From: Ian Taylor  
Sent: 16 September 2012 22:23  
To: Steve Opacic  
Cc: Ldf  
Subject: RE: Colden Common VDS 2012 DRAFT CONSULTATION - General Comments (Item 4)

### **Colden Common Village Design Statement Consultation Draft 2012**

#### General Feedback

#### Page 12 Map D

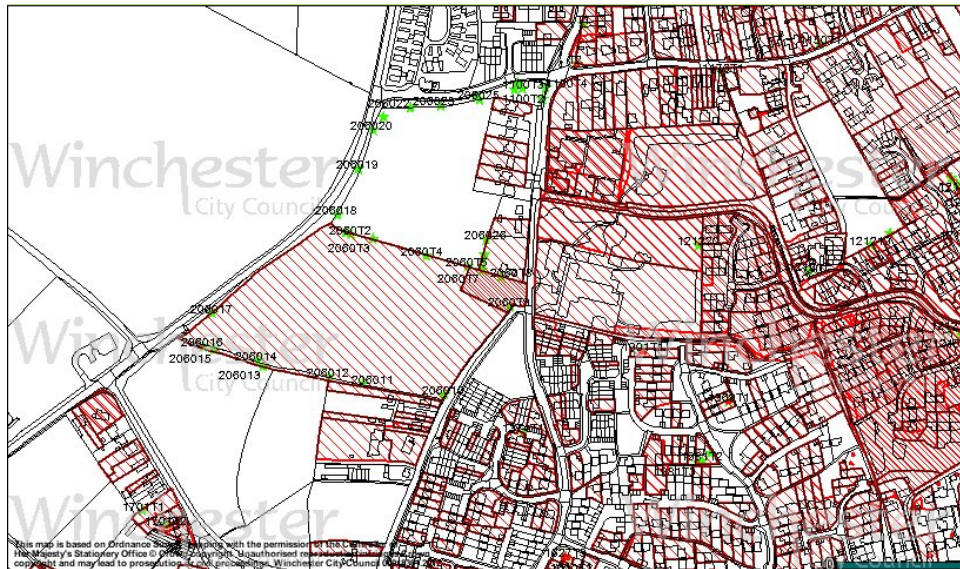
- There are several important footpaths missing from this map, the choice of highlighted paths is inconsistent.
- Recent Tree Preservation Orders need incorporation (e.g. Those to SHLAA Plot 1874).

- I'm slightly surprised there aren't more 'protected hedges' along some of the roads shown on map D
